DFX Conceptual Design Review: Outcome and Recommendations from the Review Panel

Michele Modena, on behalf of the Review Committee

- In view of the completion of the design phase and the approaching of DFX prototype procurement, TE/MS-C and HL-LHC Project called for a “**Conceptual Design Review**” of the DFX, the distribution feedbox for the new triplets, CP and D1 magnets.
- The Review Panel was charged with the following:

Evolution of conceptual design wrt cryogenic performance of DFX

Elaborated concept

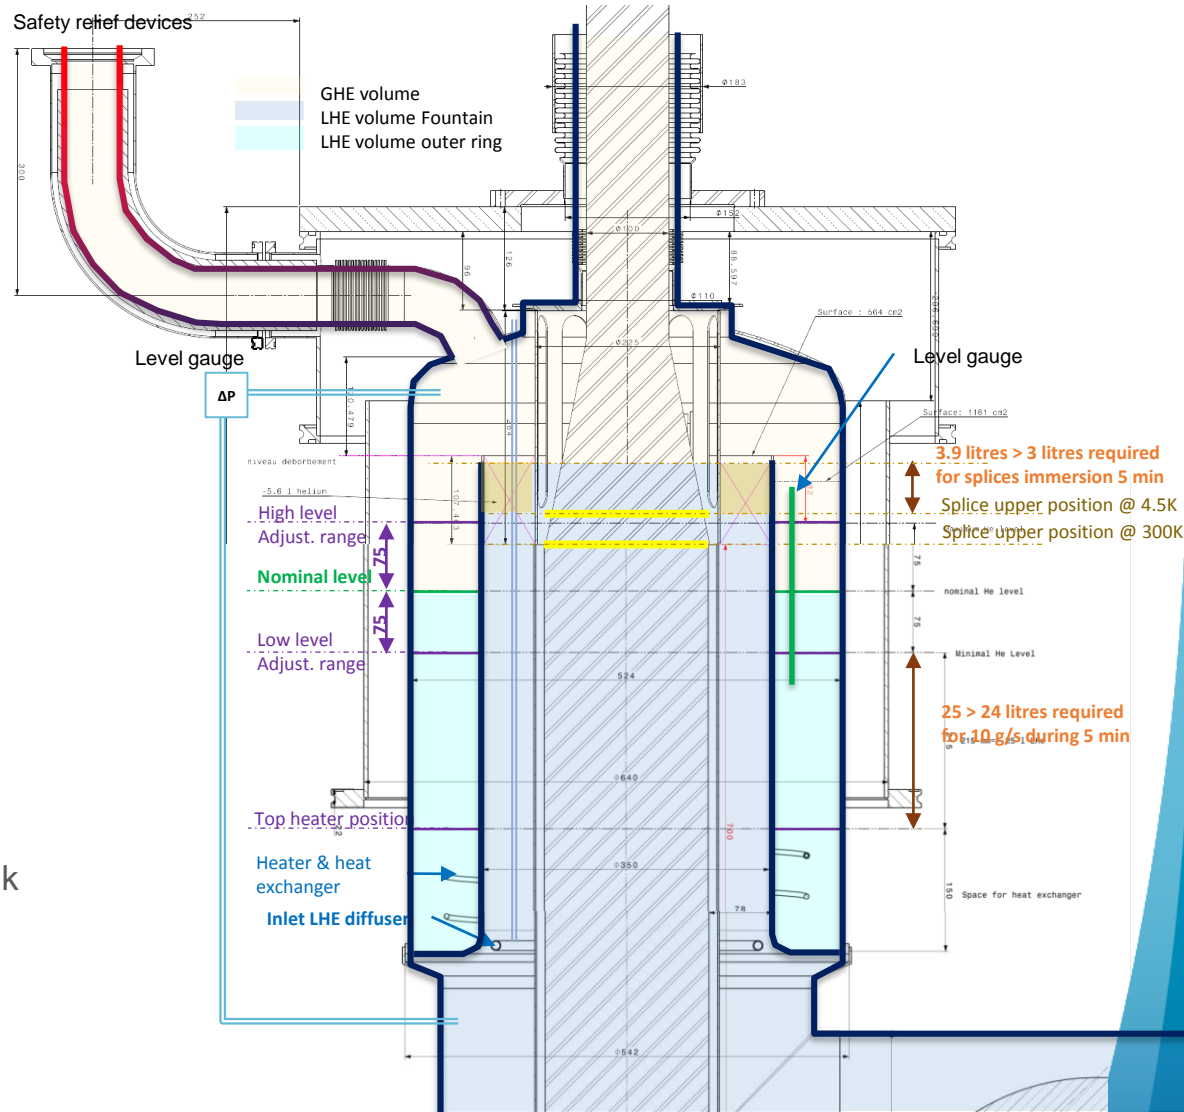
- The new proposed design, based on a “cryo-fountain” concept, seems to significantly improve and solve the open questions of helium phases separation and LHe level control. The proposal for the safety equipment implementation (safety valve and burst disk) needs further improvements.

RECOMMENDATION N.2: Complete the design of the new developed concept (“cryo-fountain”). A final optimization of the two chambers volume ratio should be done considering nominal operation conditions (5 g/s of He flow generation for the DSHX) and pre-defined limits for Cryo OK signals for powering.

The committee recommends to investigate the setting of minimum operation autonomy of the system in case of He supply cut, to 10 min.

SCLink interface (unchanged)

- Splices in rigid protection part c
- Same cables configuration

DFX helium reservoir

- Central “fountain” design
- LHe inlet, heater

Operation configuration

- Splices immersion
- Overfill to outer volume
- Level control at lower level

Levels definition

- Nominal & adjustment range
- Splices position
- 5 min requirements
 - Respect of splices immersion
 - Respect 10g/s supply to SCLink

Integration of safety devices

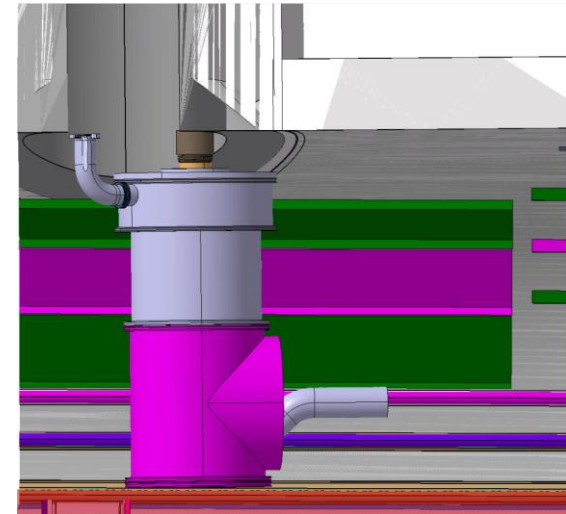
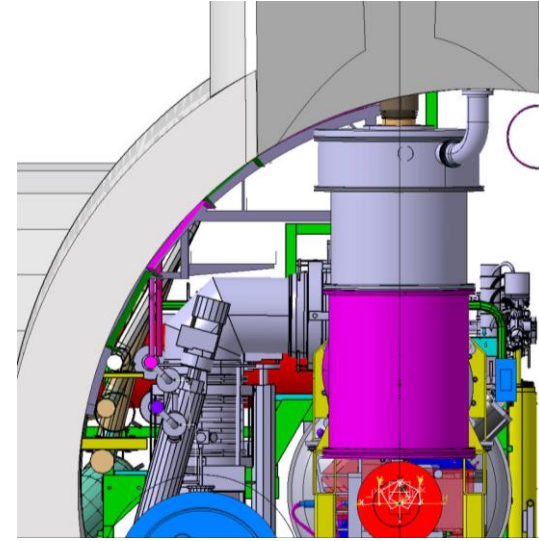
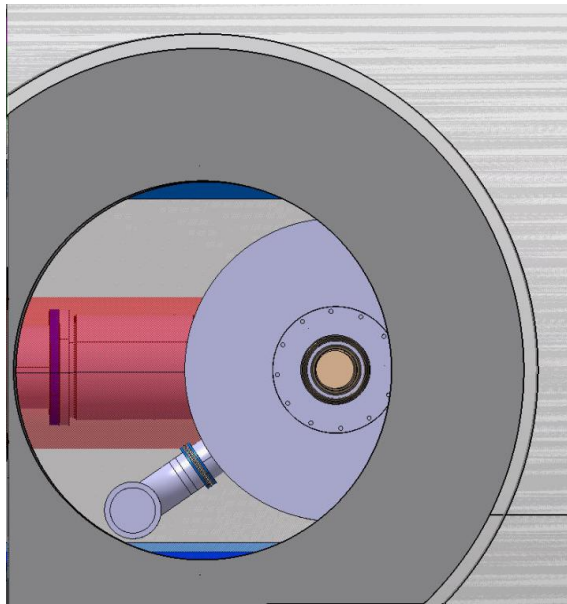
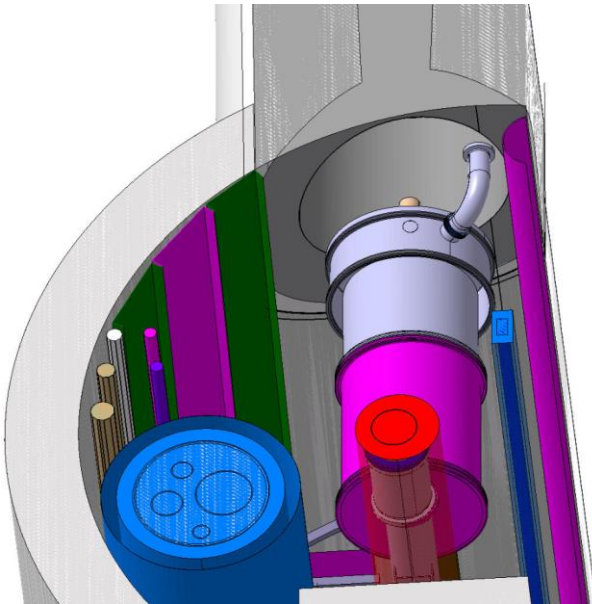
Design of the extension pipe for the safety devices shall avoid horizontal position and have enough height (potentially with thermalization) to guarantee a correct stratification of helium in order to prevent ice formation on the safety devices (this last point will need a tight collaboration with WP15 to integrate the proposed solution at the Tunnel/vertical core interface).

Safety relief devices location

- Respect of vertical distance ; device to DFX interface with He reservoir
- Accessible for inspection
